SERVICE BULLETIN No.1112

COACH MODEL : T2145 w/ ADA lift

BULLETIN TYPE : Field Change Program

SUBJECT : Rear quarter ventilation

Figure 1: Revised rear quarter ventilation on T2100 Series coaches with ADA lift

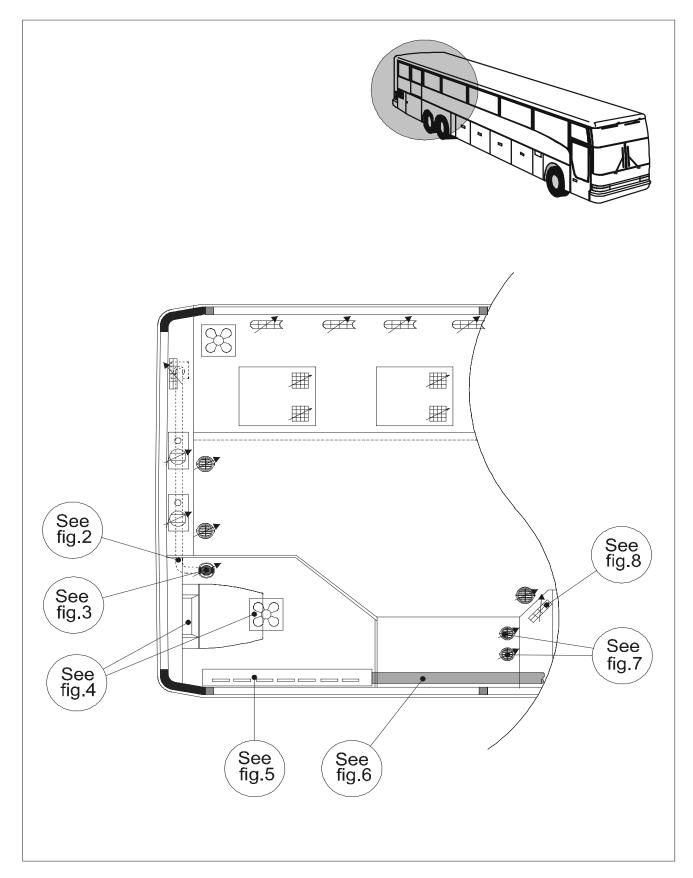
Modifications have been made regarding the location and type of air outlets used at the rear of the passenger compartment of T2100 coaches equipped with an ADA lift. The changes were cut into production to:

- Improve air distribution in the lift door area.
- Provide forced ventilation in the restroom.

This Bulletin provides information on the latest rear ventilation status, and includes a diagram and photos with the current air outlet locations. A procedure to retrofit units in the field is also provided.

- To improve ventilation in the rear quarter area, fresh air is taken from the air duct which is hidden by the molding above the rear seats, and which is then supplied to the restroom through a flex tube and an outlet in the restroom ceiling (see Figures 2a, 2b and 3).
- More air is supplied to the restroom through slots in the air outlet molding above the restroom window. This air is taken from the right hand parcel rack duct (see Figures 5, 6a and 6b).
- Used air is removed from the restroom through slots in the trim panel behind the toilet seat (see Figure 4) and evacuated to the outside through a roof mounted extractor fan.
- Additional ventilation in the area next to the rear access door is provided through two additional outlets in the parcel rack bulkhead and one in the parcel rack floor (see Figures 7 and 8).

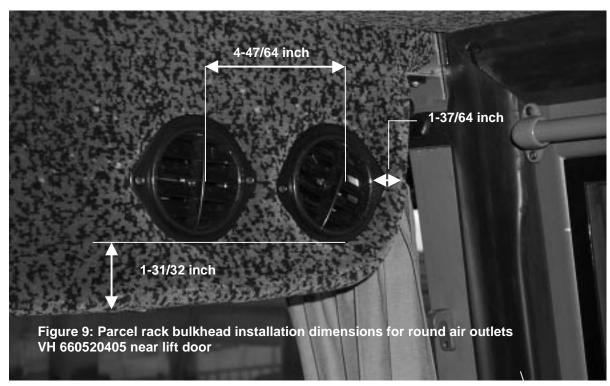
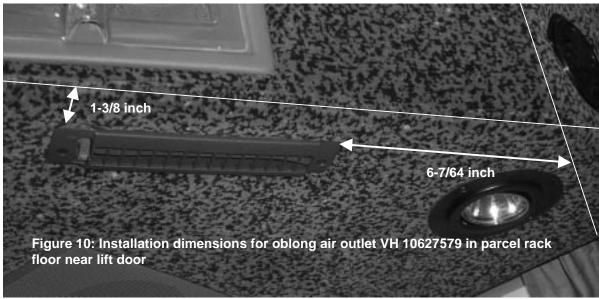
To install round air outlets VH 660520405, make a template for the two holes in the parcel rack bulkhead (see Figure 7 and nominal size chart), using a piece of suitable cardboard and dividers.

- Referring to the dimensions in Figure 9, position the template on the parcel rack bulkhead 2) and attach with masking tape.
- 3) With a utility knife follow the circumference of the two outlets, at the same time cutting through the template and the fabric. Remove the template and the wasted cloth.
- 4) Secure the fabric remaining around circumference of the holes with a stapler.
- 5) With a suitable hole saw, cut two holes in the plywood to accept the outlets.
- Install the outlets in the holes and secure them with black self-tapping screws.
- 7) Referring to the installation dimensions in Figure 10, proceed likewise for oblong air outlet VH 10627579, cutting the plywood with a reciprocating saw.

Figure 19: Location of transition duct on rear molding duct

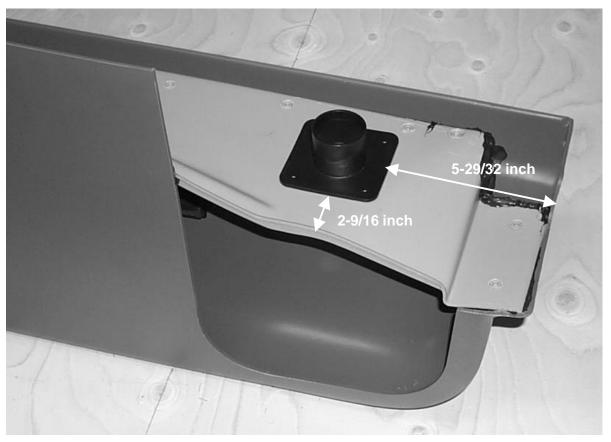
8) Install the T-shaped transition duct referring to the dimensions in Figure 19. Start by drilling a 1-5/8 inch hole in the molding duct. Center the hole in the transition duct with the hole in the molding. Secure with Sikaflex 221or a similar adhesive, rivets at the four corners, and back-up washers.

Figure 21: Installation dimensions for air outlet in restroom roof

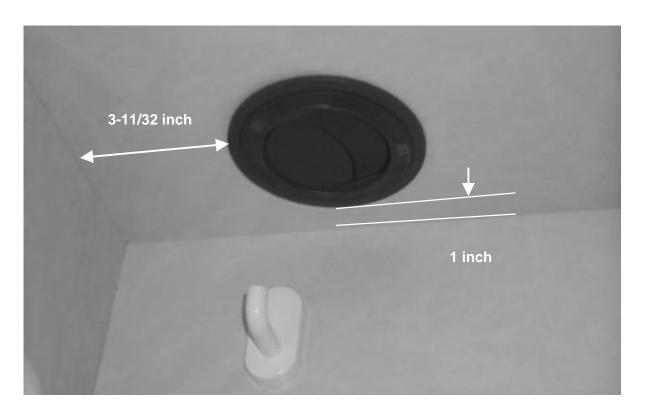
2) In the restroom, cover the area where the air outlet will be installed with masking tape (see Figure 21). Cut a hole through the tape and the ceiling using a 3-inch hole saw. Remove the tape once the hole is finished.
